BACK RIVER PROJECT  
Responses to Primary Pond Report Comments

December 5, 2022

## Responses to Primary Pond Report Comments

DRAWING NO.: **UM-PP-200**  
REVISION NO.: **A**

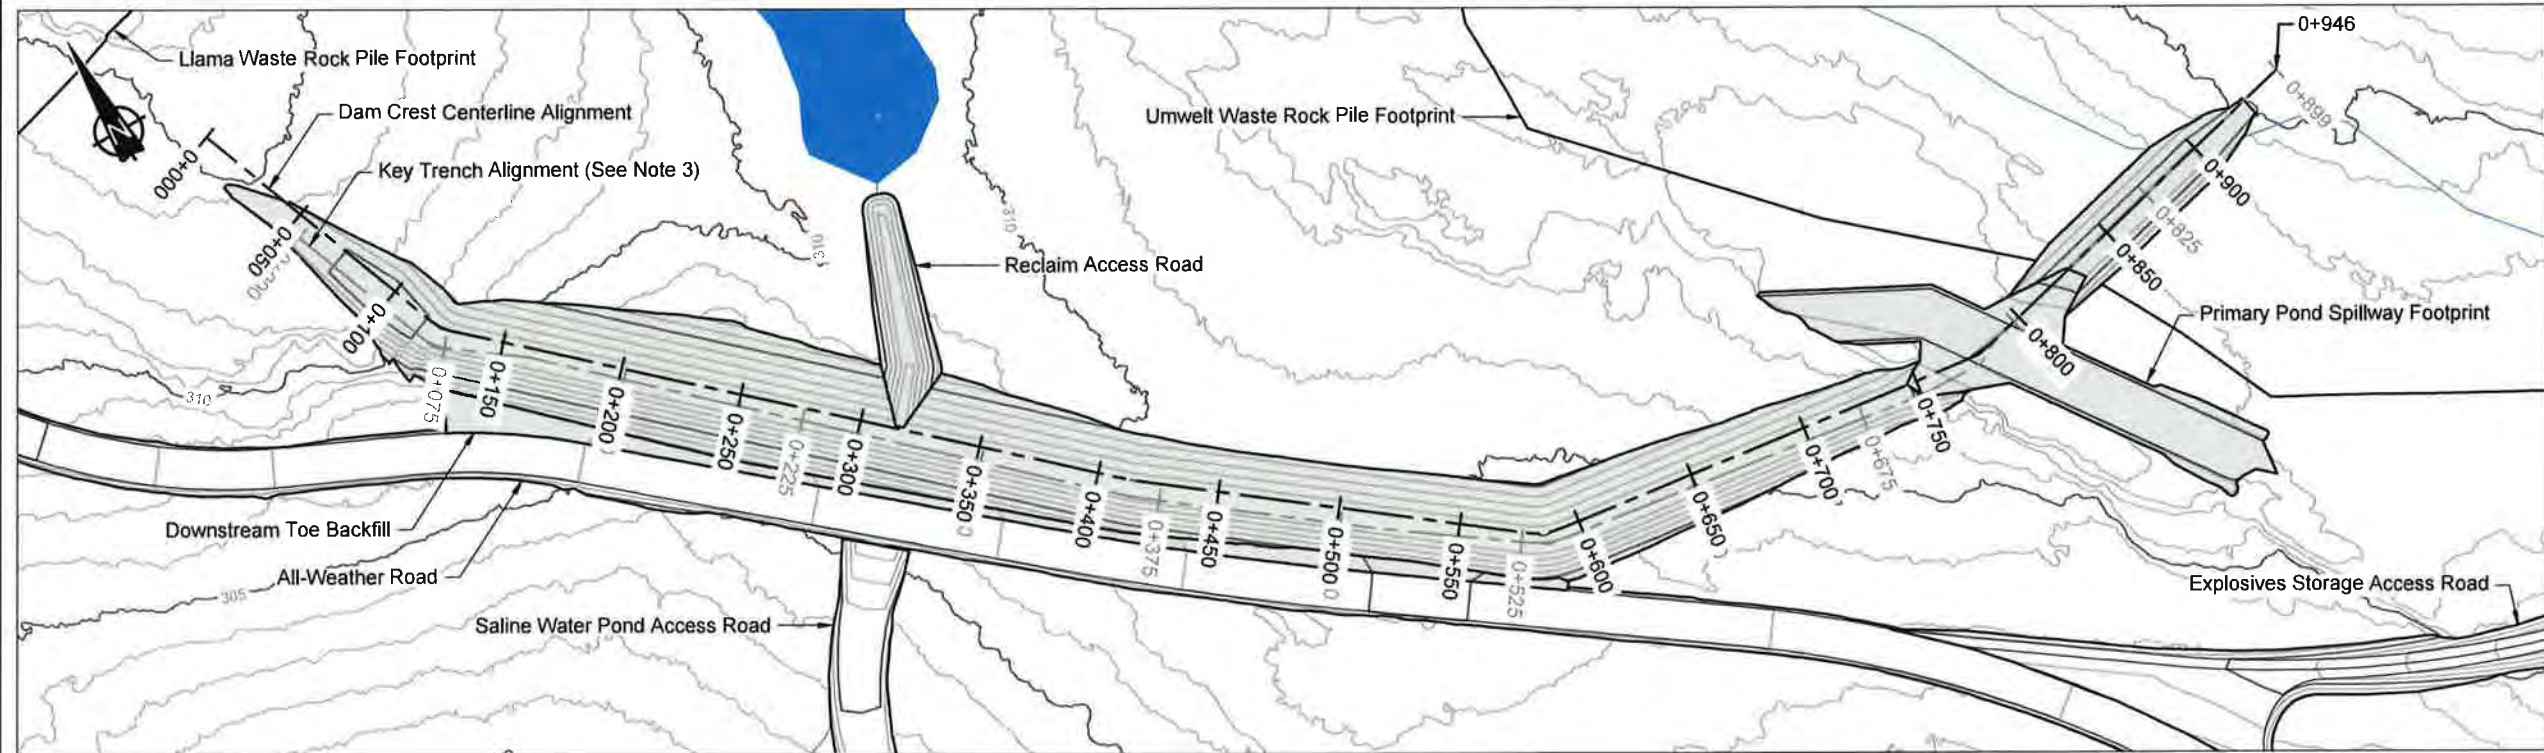
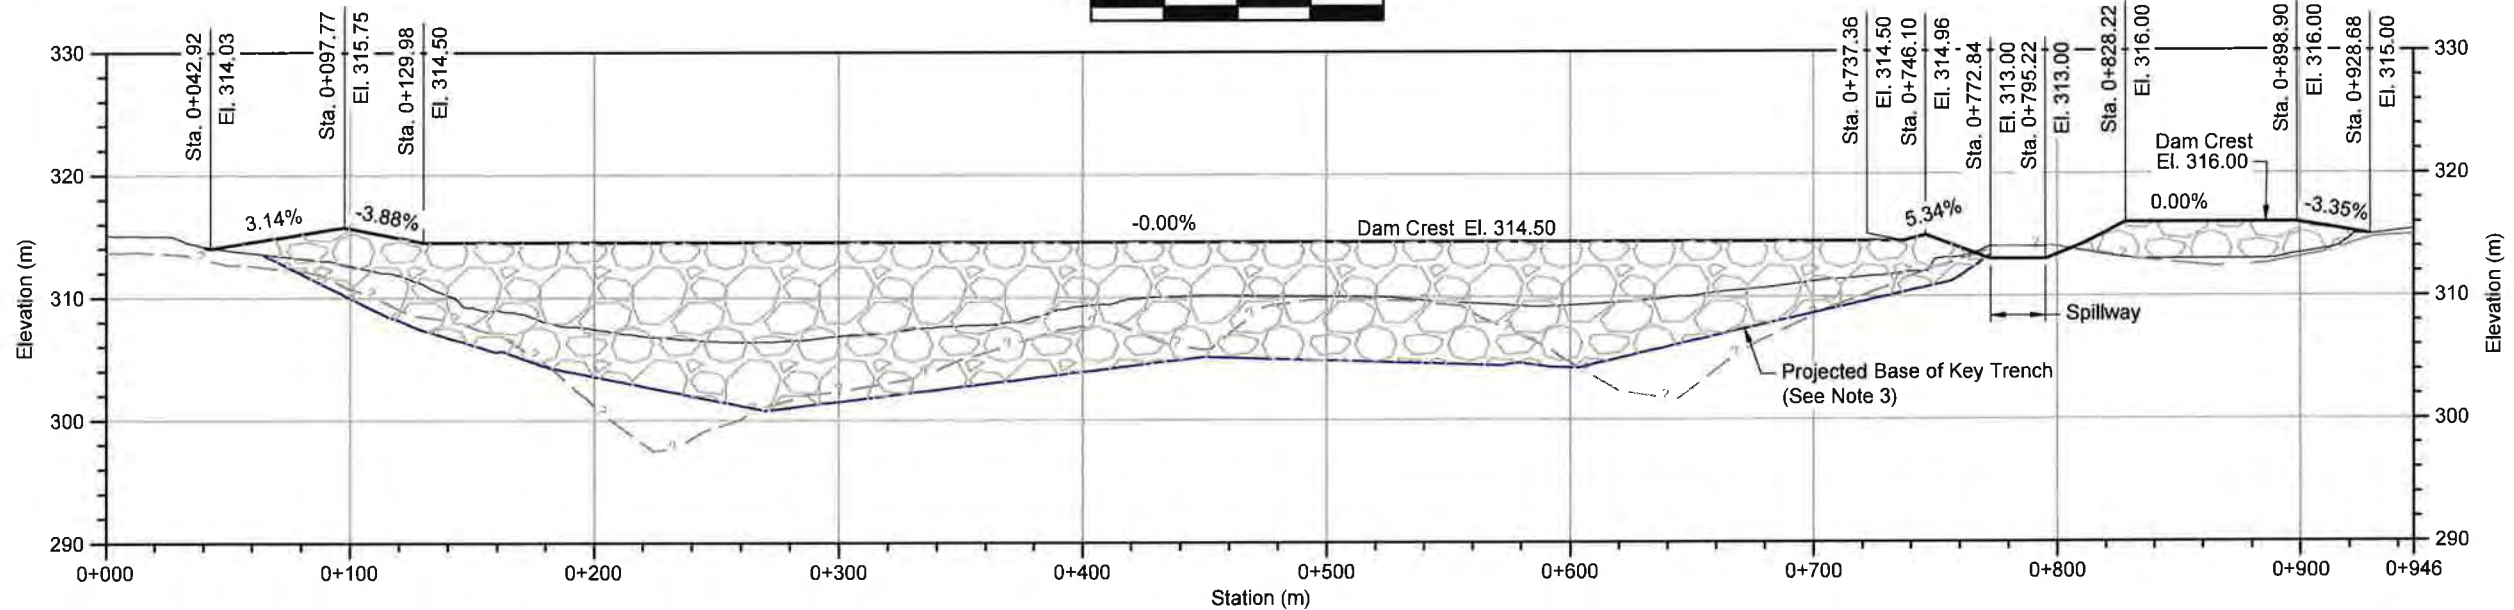
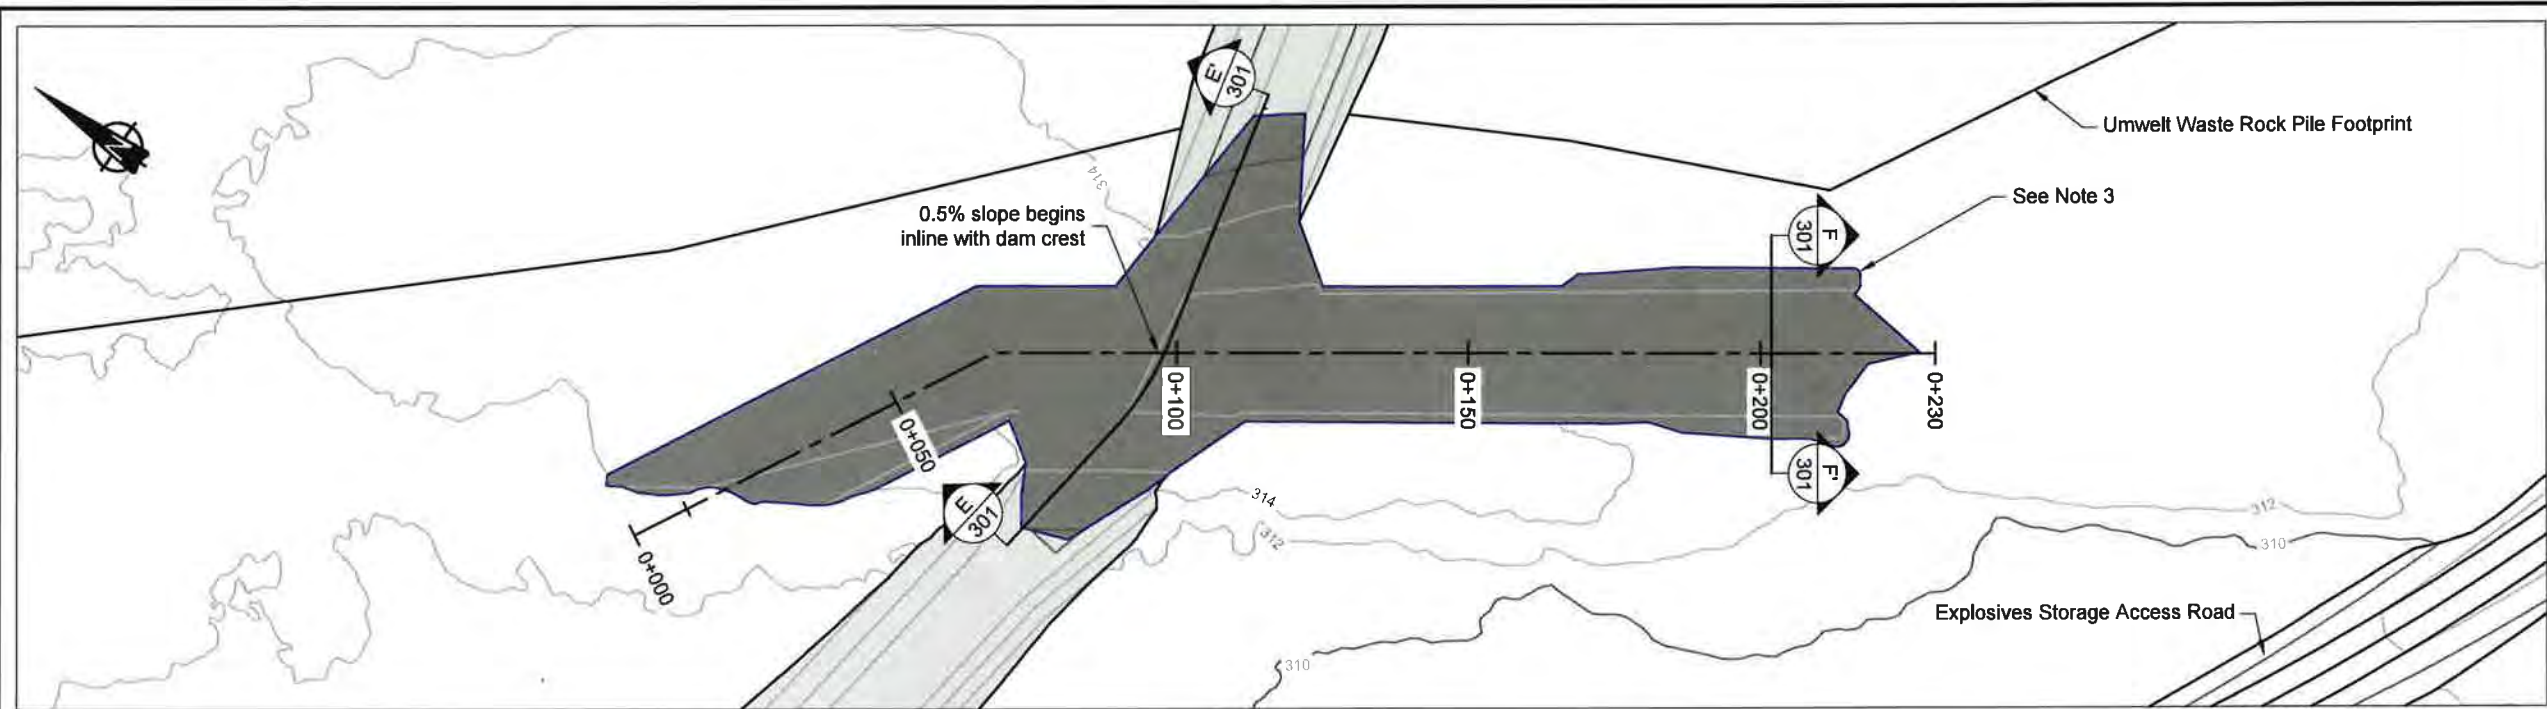
Drawing UM-PP-200 refers to “hypersaline soil” being an unsuitable foundation material, but it is not defined in the technical specifications, nor are quality control/quality assurance (QC/QA) specifications presented to assess the presence of saline soil during foundation preparation.

Sabina to update the technical specification by defining hyper-salinity and provide details on the QC/QA process for foundation preparation with respect to salinity.

Comments noted. Technical specifications will be updated to **further discuss ‘hypersaline soil’**. The next revision of the technical specifications is planned to be released immediately prior to construction.

Salinity testing was planned to be done first on the percolation testing samples (collected pre-construction) and then also on the fill material as part of construction. Additional details on this testing will be added into the technical sections (expect to be done with a handheld refractometer and as per ASTM D4542).
